THE SIZEWELL C PROJECT
(EN010012)

DEADLINE 2

WRITTEN REPRESENTATION SUBMITTED BY THE HEVENINGHAM HALL ESTATE (THE HHE)
(INTERESTED PARTY NUMBER: 20026675)

Figure 5: Park and ride site catchment areas

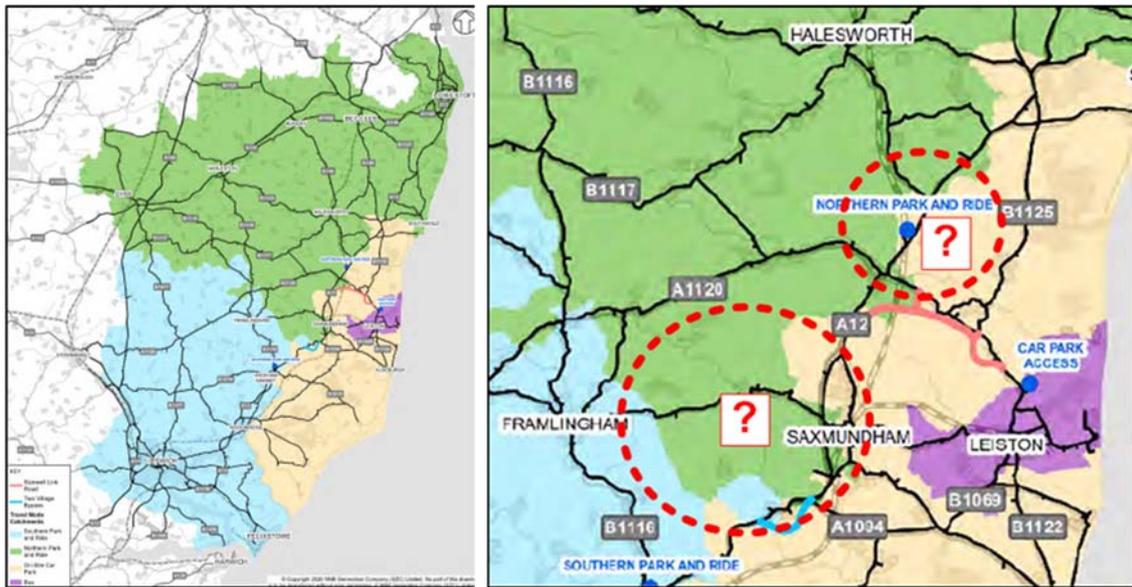
- (c) in terms of the predicted use of the NPR (see the catchment areas at **Figure 5**), there is doubt that the figures and assessment feeding into Plate 7.4: Travel mode catchments – peak construction are reliable. The Applicant needs to explain¹³:

- (i) why residents living in the immediate vicinity of the NPR are predicted to drive directly to the main development site.

Figure 7: Risk scores associated with local level crossings²⁰

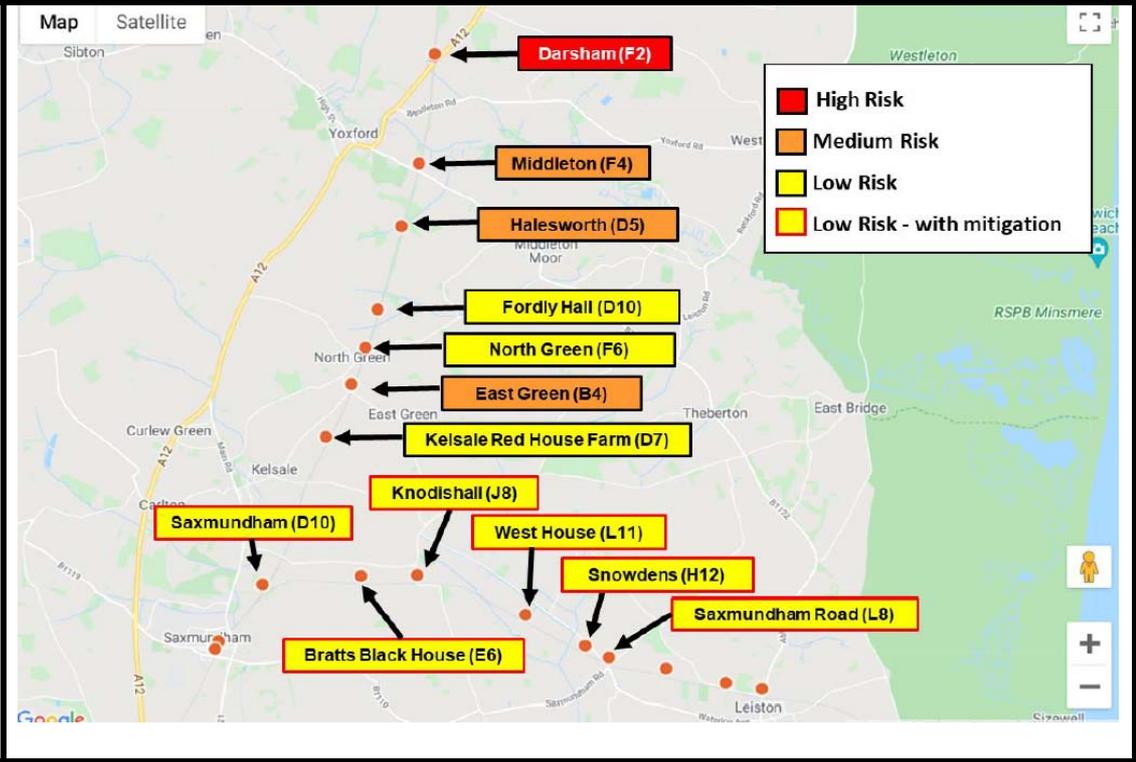
- (ii) The HHE also notes that in exploring the possibility of running more trains on the East Suffolk line, especially during the peak construction period, the Applicant acknowledged that increased use of trains as part of its revised transport strategy may require “*Network Rail to undertake improvements to level crossings on the East Suffolk line, in line with their duties as infrastructure manager, to mitigate the risk to level crossing users arising from more frequent services*”¹⁸ (emphasis added). Given this acknowledged risk, it is even more remarkable that the Applicant has not put forward any proposals to upgrade pedestrian and vehicular safety at the Darsham and Middleton level crossings, particularly at the former, which is regarded by Network Rail as the crossing with the highest rated risk, but which is also predicted to suffer the largest increase in users.

Figure 10: YR – modelling parameters in the TA Addendum and actual geometries³⁴

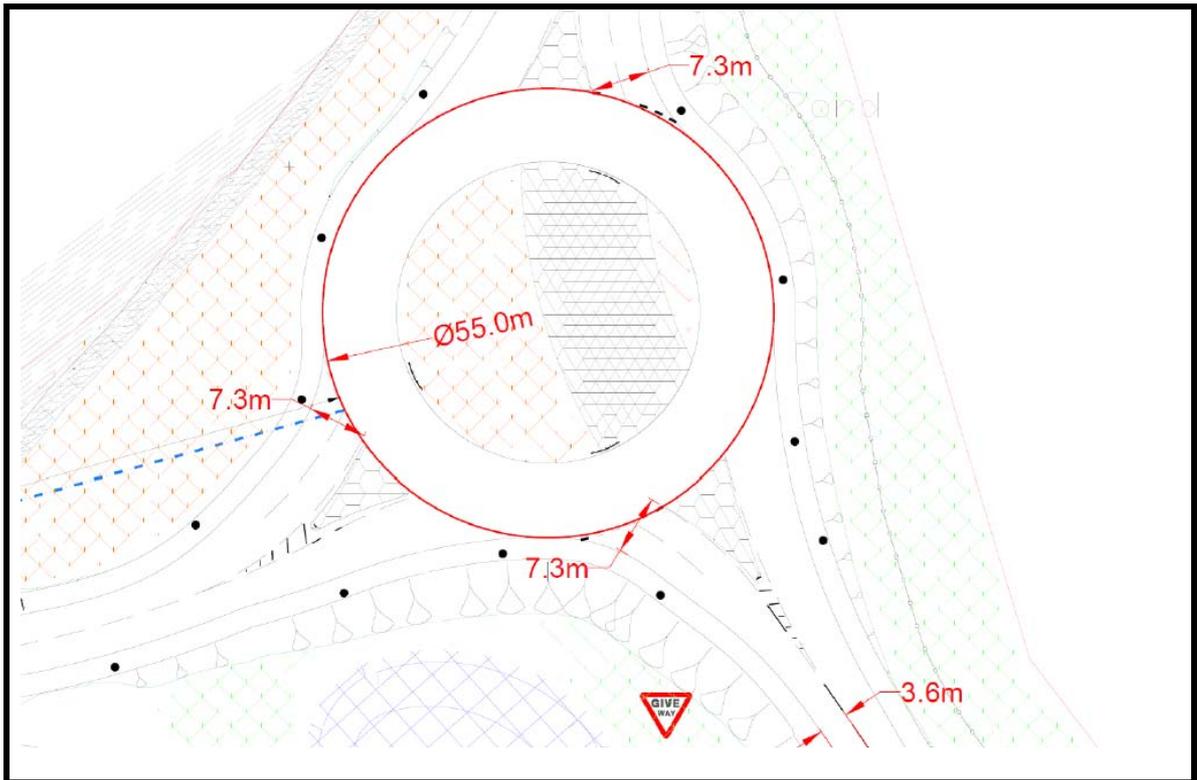
TPA measures shown in red. Approaches are 7.3 metres wide (not 4.0 metres or 5.63 metres). Full measurements appended.

- (c) re-runs the model using the actual geometries (specifically 7.3m wide entries, rather than 4m), which will allow the RFCs to reduce even further, thereby making the creation of such a large roundabout even less justifiable. See **Figure 10**.

Figure 11: Bat survey areas⁵⁶

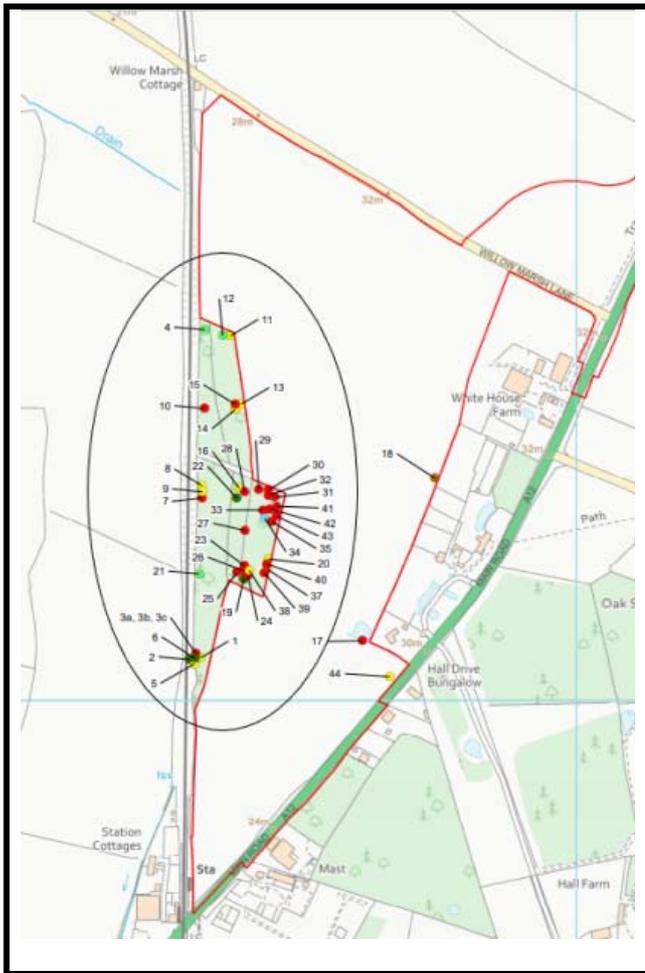
- 3.10 Without detailed survey work, it remain unknown whether the YR supports roosting bats.
- 3.11 The bat roost assessment identified two dead trees with potential to support roosting bats, with roosting features located on the eastern aspects (the location of which is shown circled black on **Figure 13**). Notwithstanding this conclusion, no further survey work has been undertaken by the Applicant on the basis access was not granted. This approach is lacking for the following reasons:

Figure 12: Newt survey areas⁵⁹

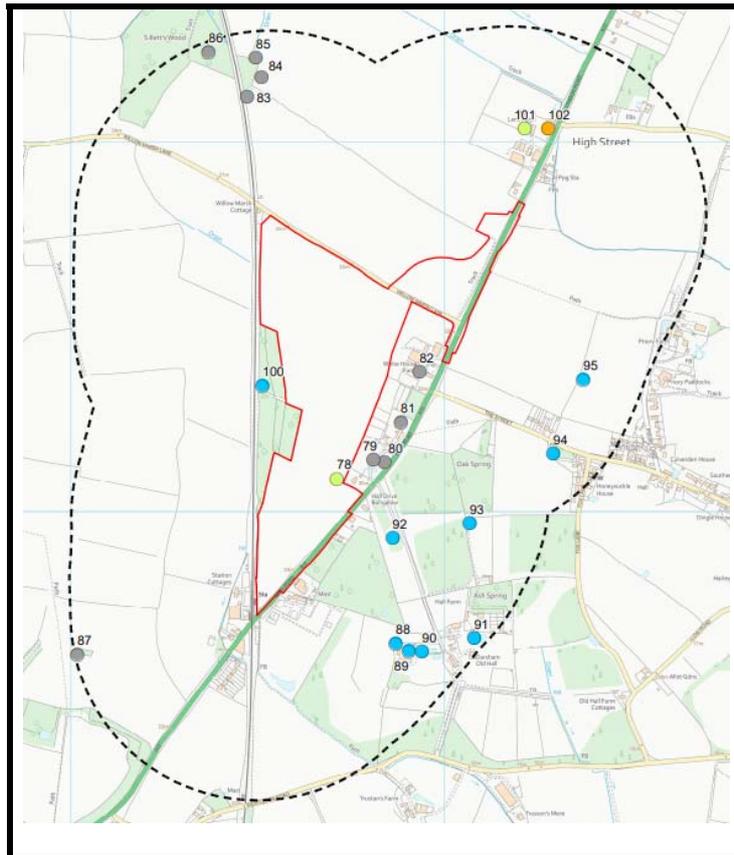
- (a) **Great Crested Newts:** Great Crested Newts are known to be present in on-site pond 78 (shown in green in **Figure 12**), and hence a European Protected Species mitigation licence from Natural England is required. However, the survey work undertaken by the Applicant is inadequate fully to assess potential effects arising from the NPR. For instance:

- (i) eight off-site waterbodies (ponds 88 - 95 shown in blue at **Figure 12**) to the east of the NPR site were scoped out of survey work on the basis that the A12 to the east of the site represents a substantial barrier to movement.⁵⁷ In Ecology Solutions' opinion, this approach is flawed. The A12 comprises a single carriageway road, with shallow, sloping kerbs. While it may pose a challenge to the movement of newts and other wildlife to other habitats, the A12 does not possess the characteristics to render it a complete barrier (e.g. a busy dual carriageway with 90 degree kerbs and gully pots). In light of this, the fact Suffolk is a stronghold for Great Crested Newts and pond 92 is located particularly close to the NPR site boundary, the Applicant should have assessed these waterbodies to inform the baseline; and

Newts. This assumption is based on aquatic survey data from a single pond (pond 78) that is now 5 plus years old and the fact a 2019 eDNA survey identified pond 101 (to the north of the NPR site) as being capable of supporting Great Crested Newts. This assumption is not robust and carries significant risk, particularly as the Applicant has assumed the meta-population is distributed across six ponds and would therefore be “less vulnerable to habitat change than similar-sized populations based on single breeding ponds”.⁵⁸ Indeed, the reality could be the exact opposite i.e. the entire population of Great Crested Newts only utilizes pond 78 (as well as pond 101 to the north), the upshot being losses to habitat would be of even greater importance to the population.

Figure 17: Study areas

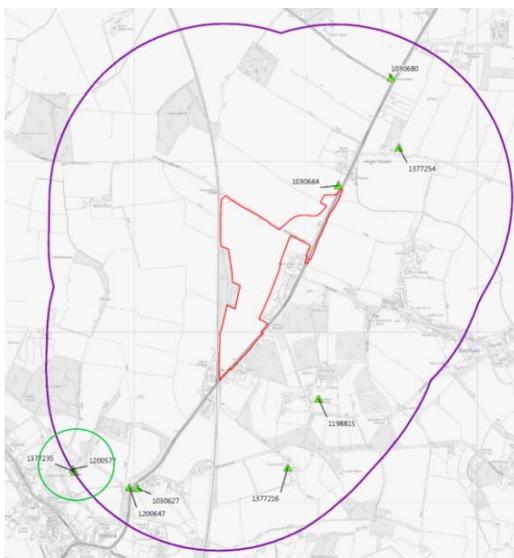
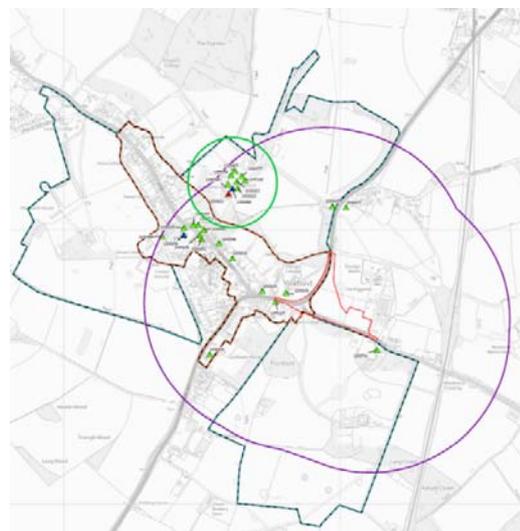
- (b) Cockfield Hall falls clearly within the 500m study area for the YR (see area circled green on **Figure 17**);

- (c) Cockfield Hall is located on the very edge of the 1 km study area for the NPR (see the area circled green on **Figure 17**) and includes a number of curtilage listed buildings located within the relevant assessment area. In fact, the Applicant only considered two heritage assets (Oak Hall LB II 1030664 and LB II 1198815) worthy of assessment by reason of potential indirect effects in connection with the NPR. To scope the designated assets identified within the study area out of further assessment based on supposed direct and indirect effects is clearly a flawed methodology and fails to take proper account of the wider array of assets' significance. It follows that harm cannot be properly determined.
- (d) increased traffic in connection with the NPR and the YR is likely to affect the setting of heritage assets such as Cockfield Hall and the rest of the complex.

An extract from Works Plans Sheet 24 is shown below with these features marked for reference.

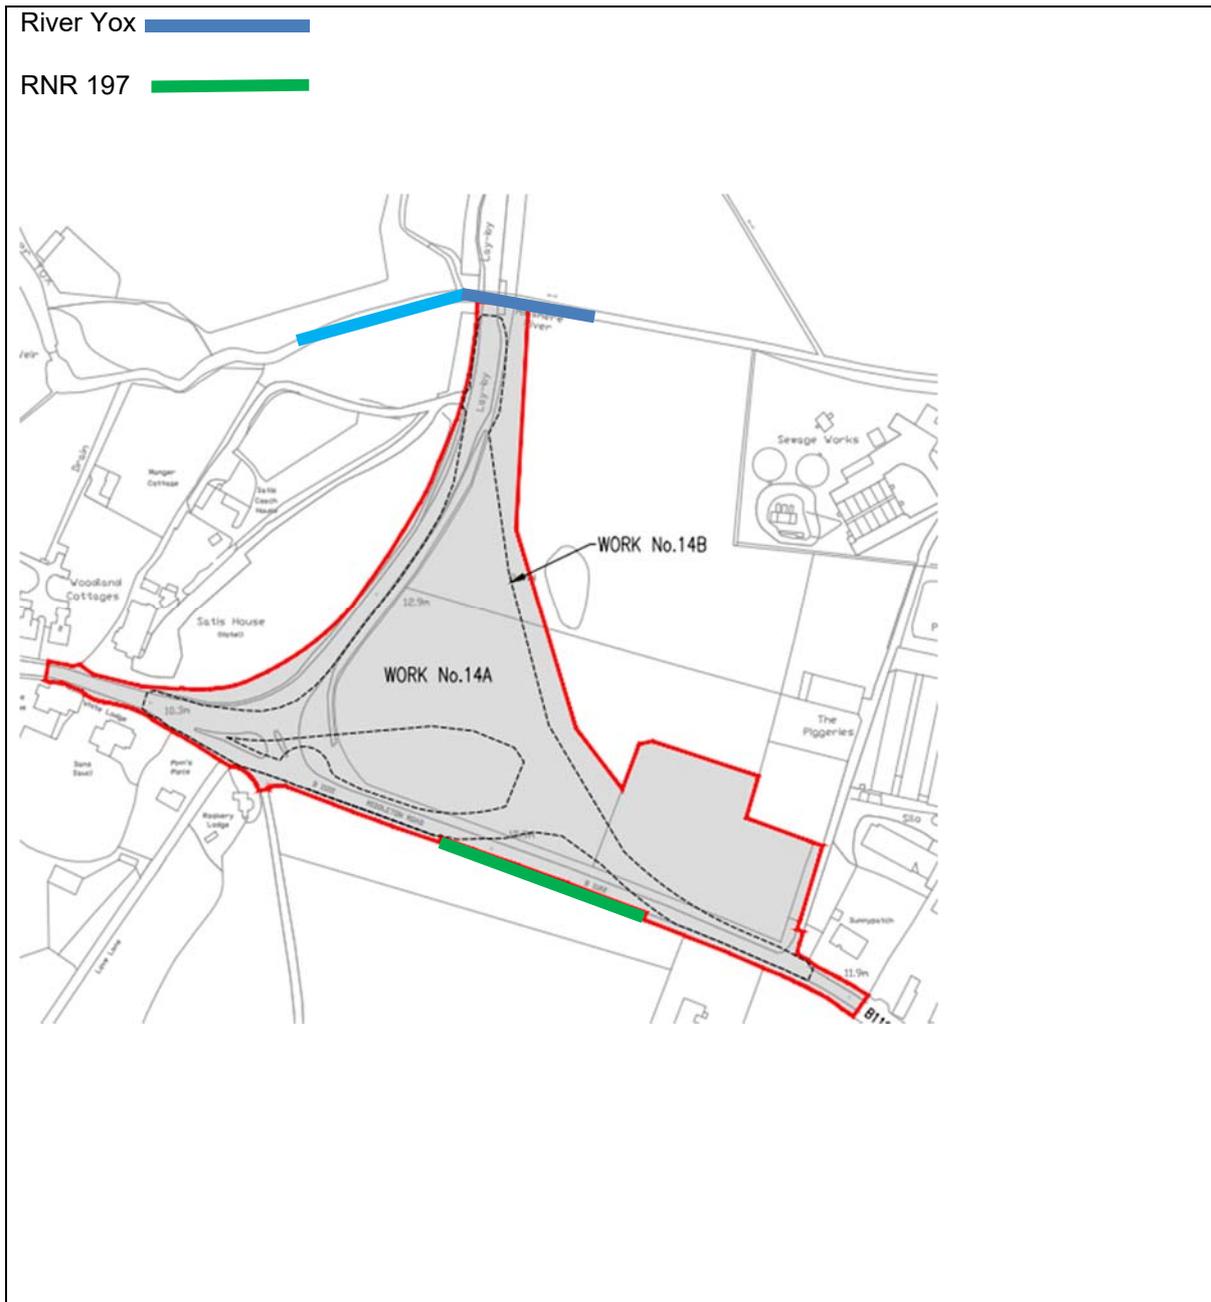
Immediately adjacent to the boundary of the YR works there are ecologically important features, including Roadside Nature Reserve 197 and the River Yox. RNR 197 includes a legally protected species, namely the Sandy Stilt Puffball fungus, included in Schedule 8 of the Wildlife and Countryside Act 1981.

(1) No development must commence in respect of Work Nos. 1A (main development site), 3 (accommodation campus), 4 (rail), 9 (northern park and ride), ~~and~~ 10 (southern park and ride) [and 14 \(voxford roundabout\)](#) until a terrestrial ecology monitoring plan for that work reflecting the monitoring included in the Environmental Statement has been submitted to and approved by the local planning authority. (2) The terrestrial ecological monitoring plan must include an implementation timetable and must be carried out as approved.
